A-24:109 – 64 Main Street East, Hamilton

File# A-24-109

Re: 64 Main St E

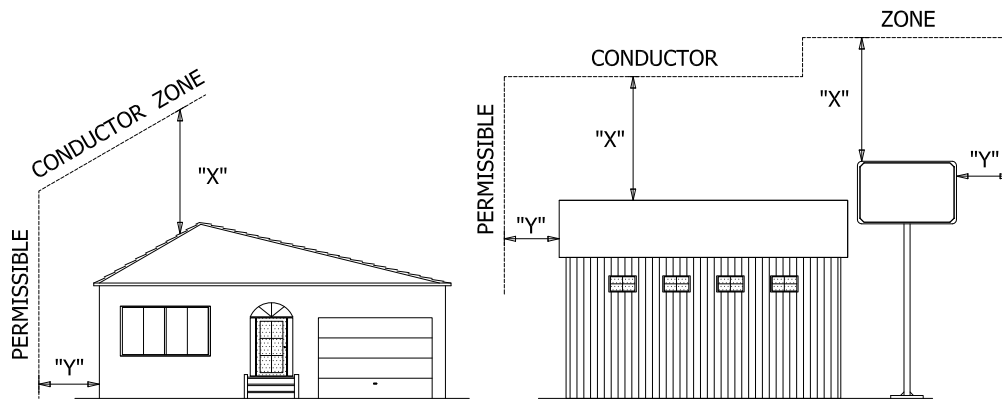
- Minimum 4m horizontal clearance from existing O/H line(s) must be maintained at all times as per Alectra Utilities Standard 3-105. Please consult with Alectra Utilities if further clarification is required.
